SERVICE BULLETIN

N° **189-314**

ATA 28 - AUXILIARY CENTRAL TANK UPGRADE

This Service Bulletin is issued in order to provide the necessary instruction to perform the upgrade from kit “auxiliary central tank” P/N 8G2810F00111 to “kit auxiliary central tank” P/N 8G2810F00112.

Figure 12

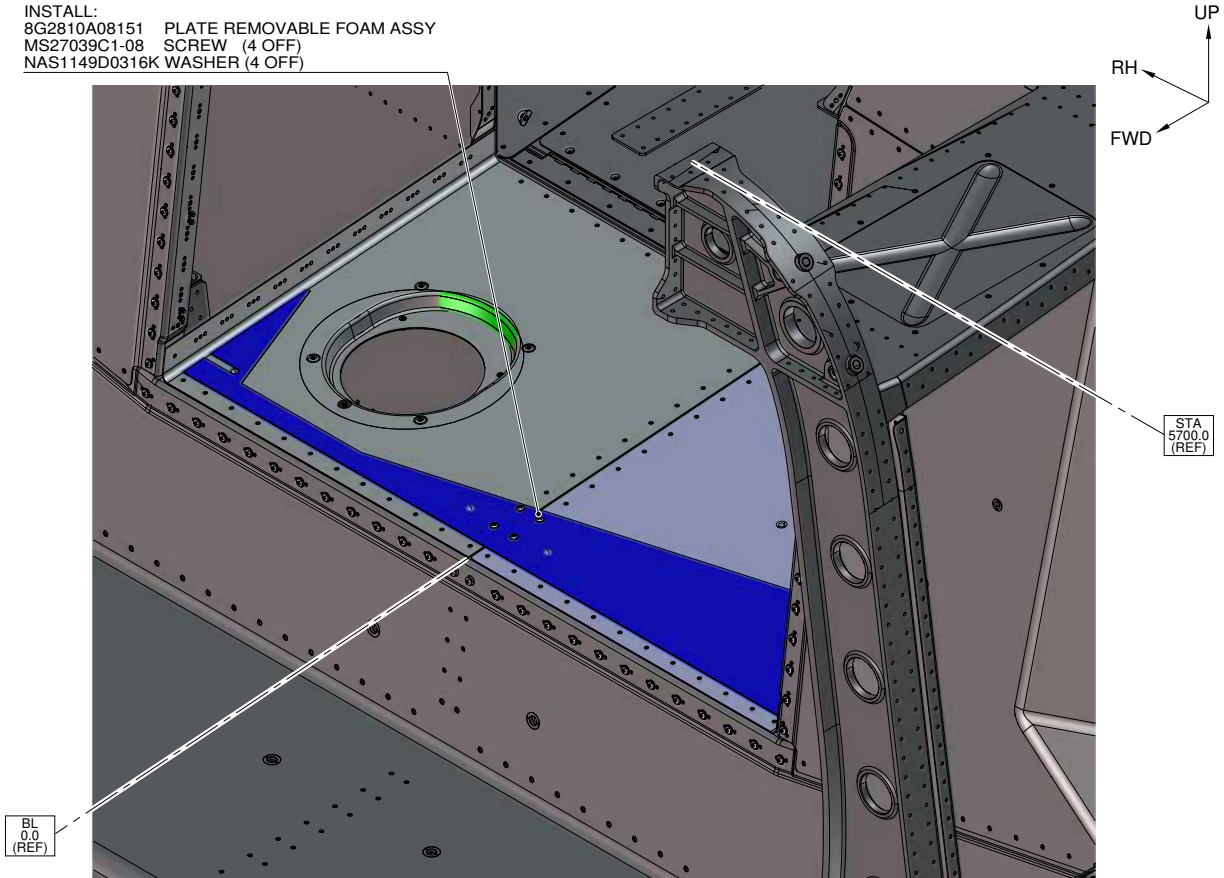
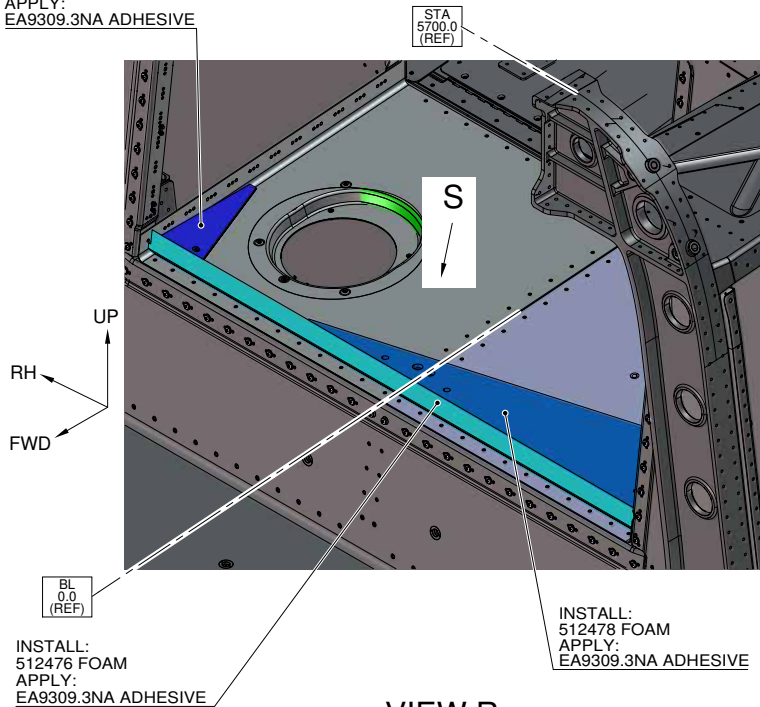
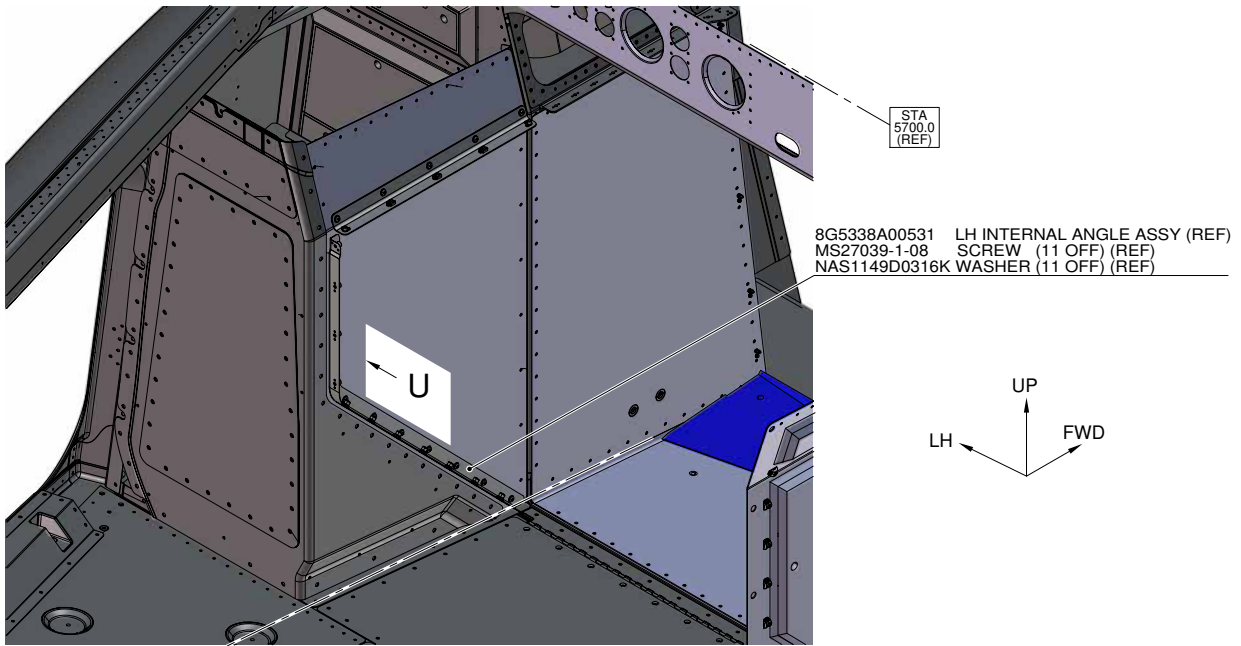
- 3.20 With reference to Figure 11 View P, remove the foam P/N 512476, the foam P/N 512477, the foam P/N 512478.
4. With reference to Figure 12 View Q, install the plate removable foam assy P/N 8G2810A08151 by means of n°4 screws P/N MS27039C1-08 and n°4 washers P/N NAS1149D0316K.

5. With reference to Figure 12 View S, rework the plate as indicated.
6. With reference to Figure 12 View R, install the foam P/N 512476, the foam P/N 512477, the foam P/N 512478 by means of adhesive EA9309.3NA (C021) on the plate removable foam assy P/N 8G2810A08151.

7. With reference to Figure 12 View S, rework the foam as indicated.
8. With reference to Figure 13 View U, rework the previously removed LH internal angle assy P/N 4F5338A03431 as indicated and re-mark with P/N 8G5338A00531 (Ref. step 3.19).

DRILL:
HOLE Ø10.0
ONLY THROUGH PLATE
(TYP 2 PLACES)

DRILL:
HOLE Ø15.0
ONLY THROUGH PLATE
(TYP 2 PLACES)

DRILL:
HOLE Ø14.0
ONLY THROUGH FOAM
(TYP 4 PLACES)

DRILL:
HOLE Ø5.156-5.283
ONLY THROUGH PLATE
(TYP 4 PLACES)

Figure 13

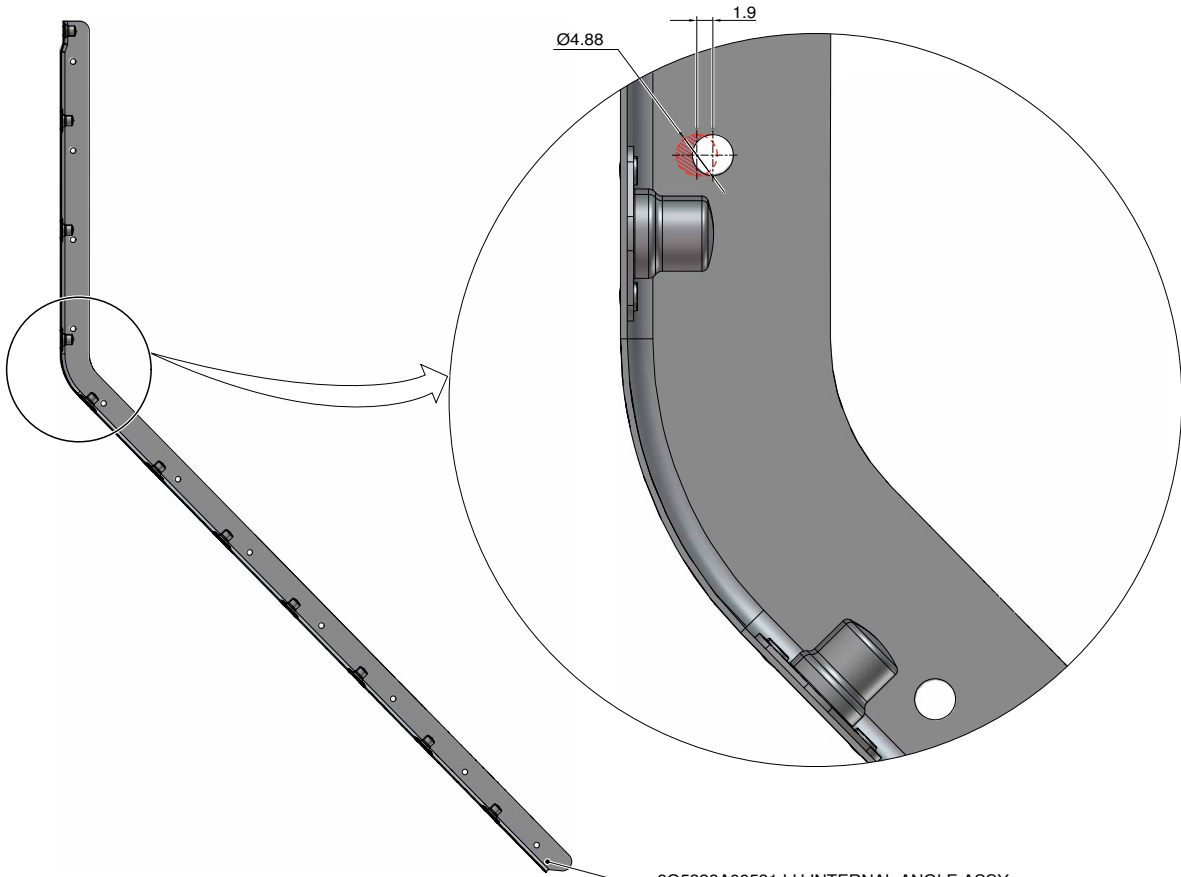
9. With reference to Figure 13 View T, install the LH internal angle assy P/N 8G5338A00531 by means of the previously removed hardware (Ref. step 3.19).

Figure 14

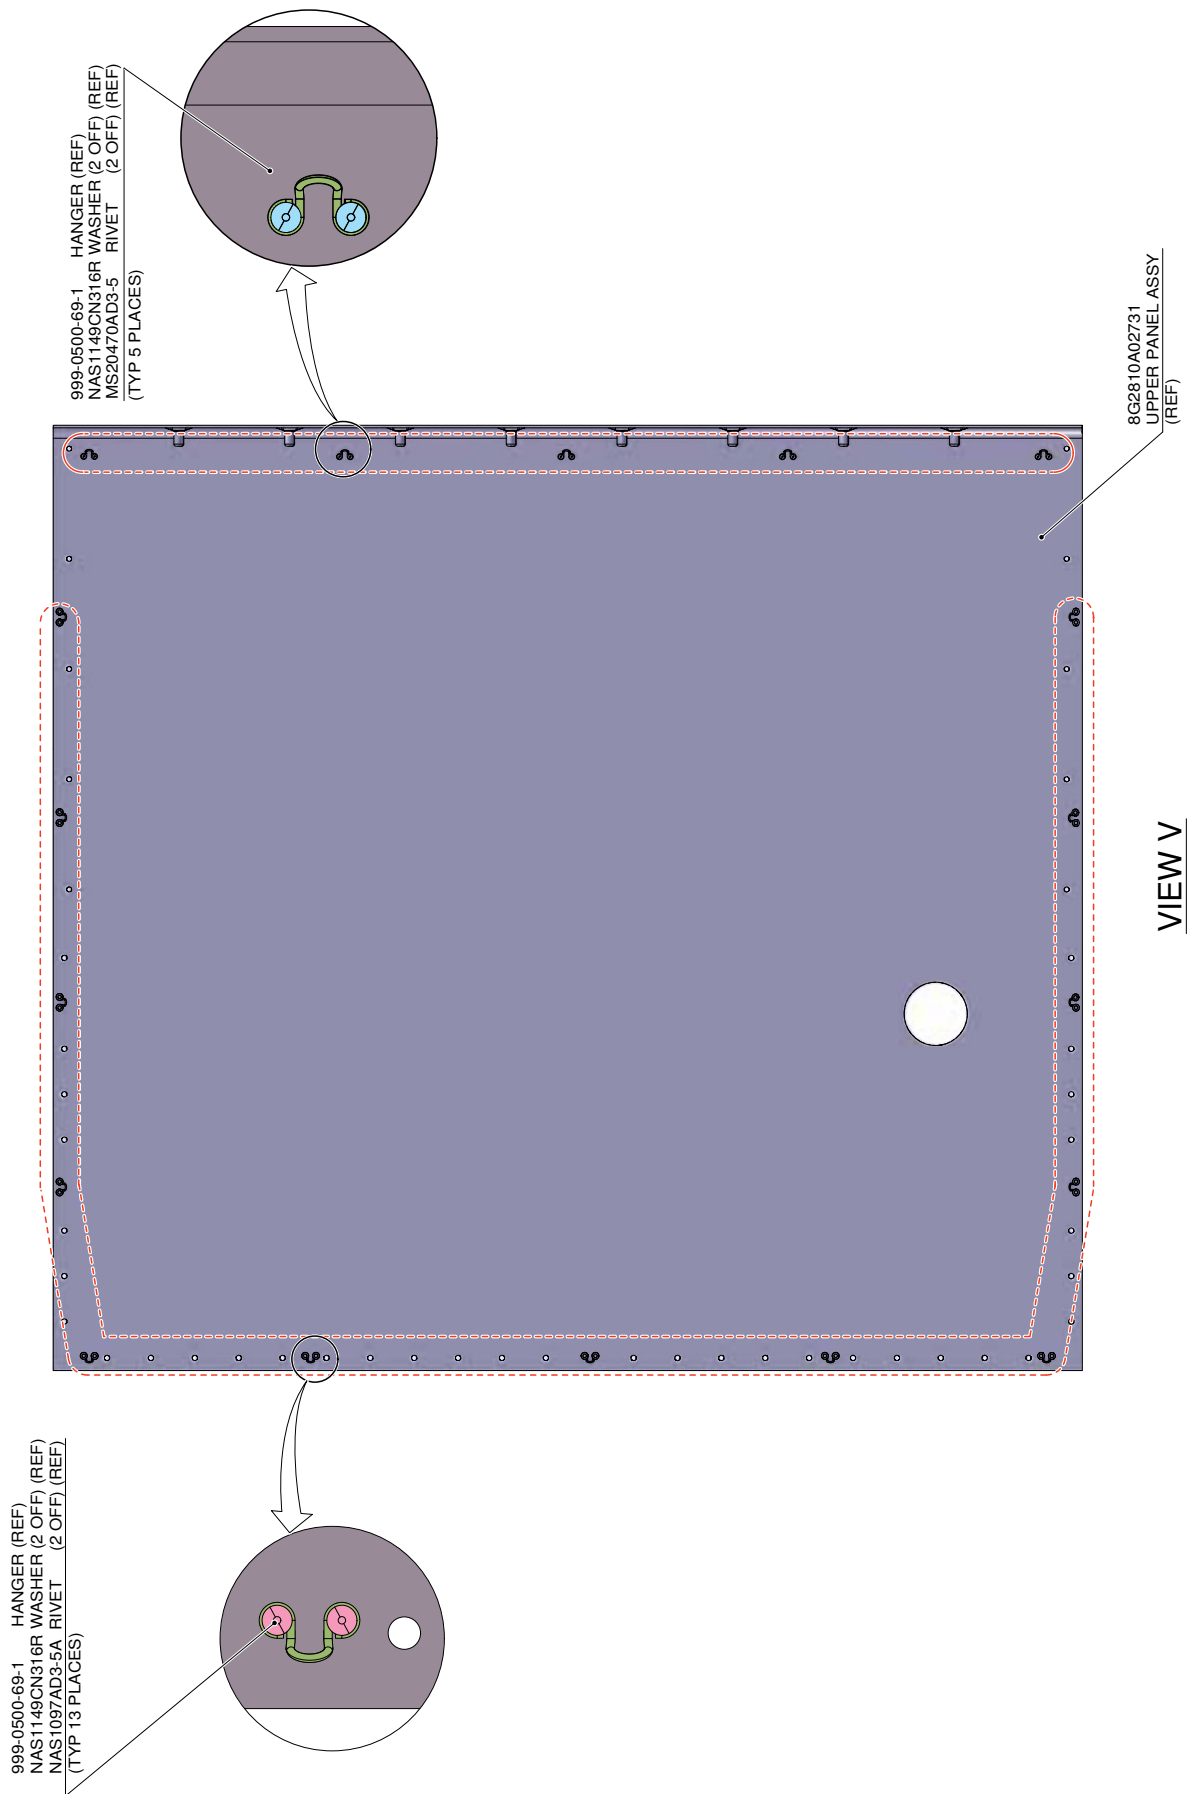
10. With reference to Figure 14 View V, re-mark the previously removed upper panel assy P/N 8G2810A02731 with P/N 8G2810A02732 (Ref. step 3.18).

Figure 15

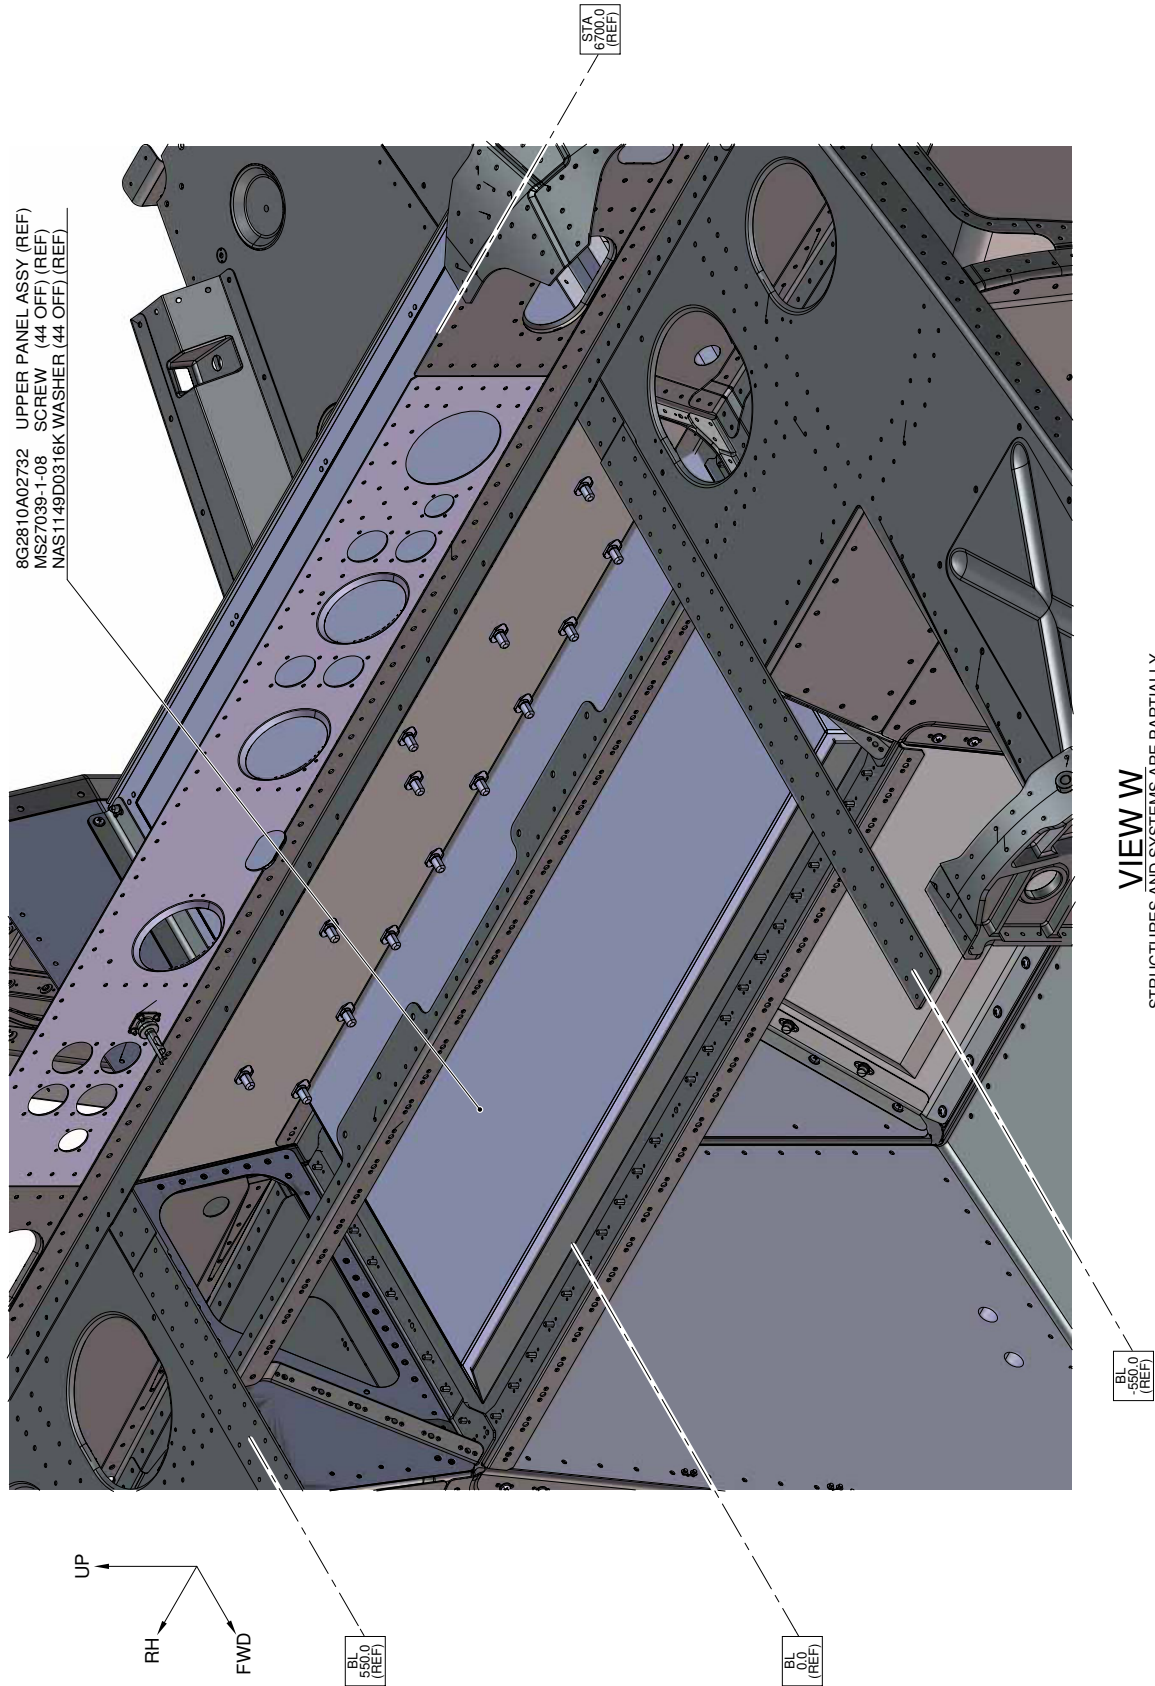
11. With reference to Figure 15 View W, install the upper panel assy P/N 8G2810A02732 by means of the previously removed hardware (Ref. step 3.18).
12. With reference to Figure 5 View D, re-install the full cover angle P/N 8G5330A09551 by means of the previously removed hardware (Ref. step 3.14).

Figure 17

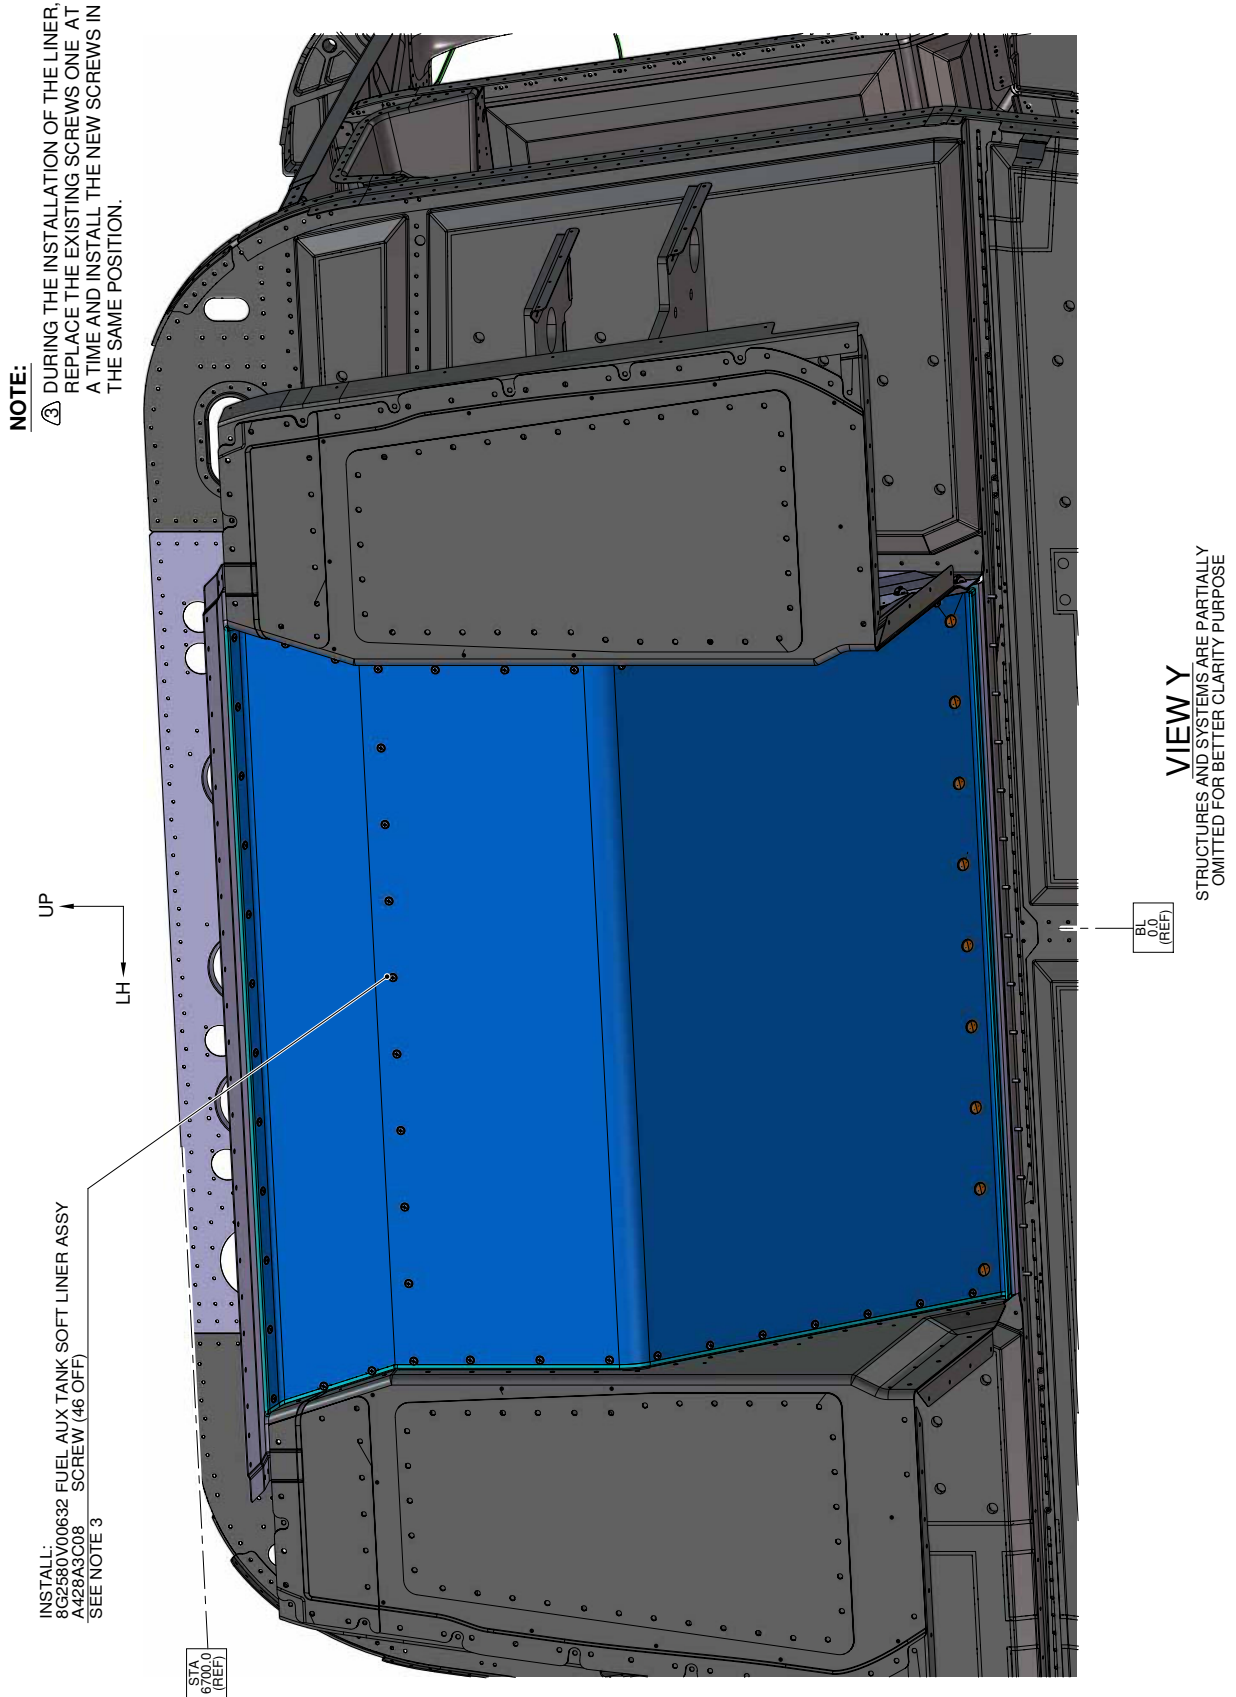
20. With reference to Figure 17 View Y, install the fuel auxiliary tank soft liner assy P/N 8G2580V00632 by means of n°46 screws P/N A428A3C08.
21. With reference to Figure 19 View AB and View AC, re-mark the previously removed centre fuel tank panel assy P/N 4F5330A69732 with P/N 8G5330A97631 (Ref. step 3.2).
